Water Management Inspection - Hamlet of Pelly Bay, August 15, 1997

Inspection Report

Pelly Bay
Unlicensed

Pelly Bay - August 15, 1997

8

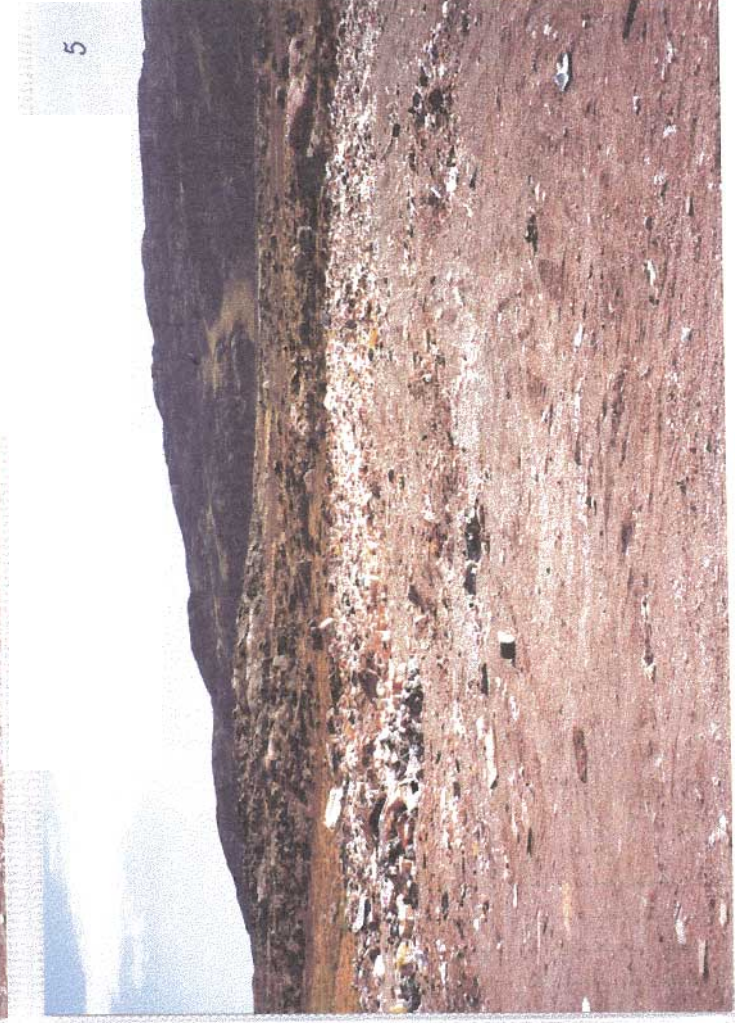
1. Truckfill station.
2. Aerial view. Arrow denotes location of truckfill station on river.
3. Creek where people go to collect water. Public Health had taken an interest in this source.
- 4-6. Waste disposal site. Accumulated garbage is due to Public Health's direction to the Hamlet not to burn the dump.
7. Trench to divert runoff water from entering the dump.
8. Waste oil - stacked and palletized.
9. Bulky metal disposal site.
- 10-14. Views of sewage disposal area. Note in 11+12 (arrow) an area of repair as lagoon washed out in June of last year. Photo 13 shows 'wetlands' area below lagoon. Photo 14 is reverse view.
15. Aerial view of community and waste disposal facilities (to show relative distances). Solid waste is on the left, sewage on the right.
